YEAR
1991 – 95

MODEL
Legend

BULLETIN NO.
97-024

Rattle From the Catalytic Converter Upper Cover

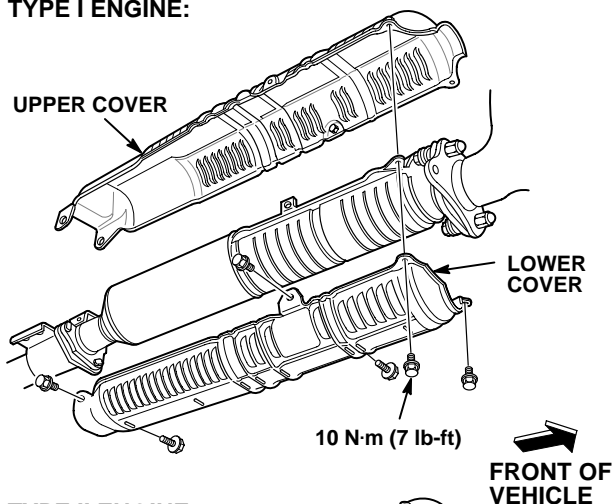
A rattle is heard from the floor of the car, especially during acceleration.

One or more of the mounting points are broken on the upper cover of the catalytic converter.

Replace the catalytic converter upper cover and its six mounting bolts. (The new upper cover comes with new bolts.) If you damage the lower cover while removing the upper cover, replace it too.
